Access Compliance Report Public Rights-of-Way (Curb Ramps)

Main Street: KEMPTON_DR Cross Street: MONTECITO_RD Location: NW

ADA ID: RPRK211208123138 Ramp Type: Type 4 - Parallel Initial Pass/Fail: Fail Overall Compliance: No Severity Score: 15

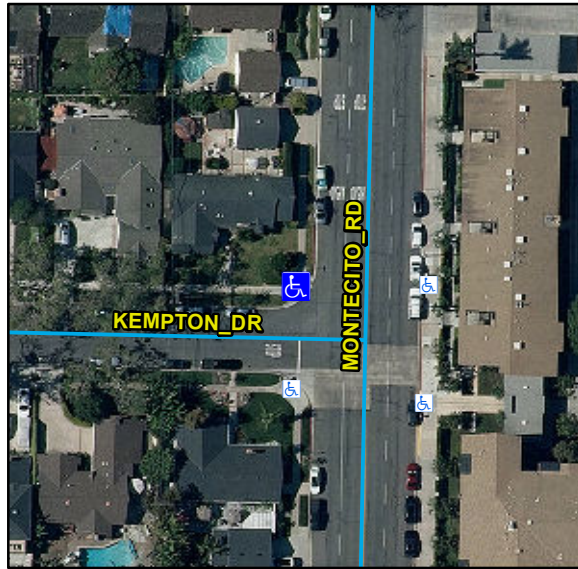
Compliance	Description	Data	Compliance	Description	Data
N/A	Ramp Length LT (in)	62	N/A	Ramp Length RT (in)	80
Yes	Ramp Width LT (in)	115	Yes	Ramp Width RT (in)	115
Yes	Ramp Run Slope LT (%)	5.6	Yes	Ramp Run Slope RT (%)	4
No	Ramp Cross Slope LT (%)	2.1	No	Ramp Cross Slope RT (%)	7
N/A	Landing Present	N/A	N/A	DWS Provided	N/A
N/A	Landing Length (in)	N/A	N/A	DWS Contrast	N/A
N/A	Landing Width (in)	N/A	N/A	DWS Length (in)	N/A
N/A	Landing Run Slope (%)	N/A	N/A	DWS Full Width	N/A
N/A	Landing Cross Slope (%)	N/A		DWS Offset Type	N/A
N/A	Landing Movement Obstructed?	N/A	N/A	DWS Offset Left (in)	N/A
	Landing Movement Type	N/A	N/A	DWS Offset Right (in)	N/A
N/A	Landing Shared	N/A			
N/A	Clear Space	Yes			
N/A	Clear Space To Crosswalk (in)	N/A			
N/A	Marked Crosswalk 1	No	N/A	Marked Crosswalk 2	No
	Crossing 1 Direction	S		Crossing 2 Direction	E
	Marked Crosswalk 1 Width (in)	N/A		Marked Crosswalk 2 Width (in)	N/A
N/A	Ramp Inside Crosswalk 1	N/A	N/A	Ramp Inside Crosswalk 2	N/A

Remove & Replace Curb Ramp With Two New Directional Ramps or Equivalent.

R304.5.3, STD 1115
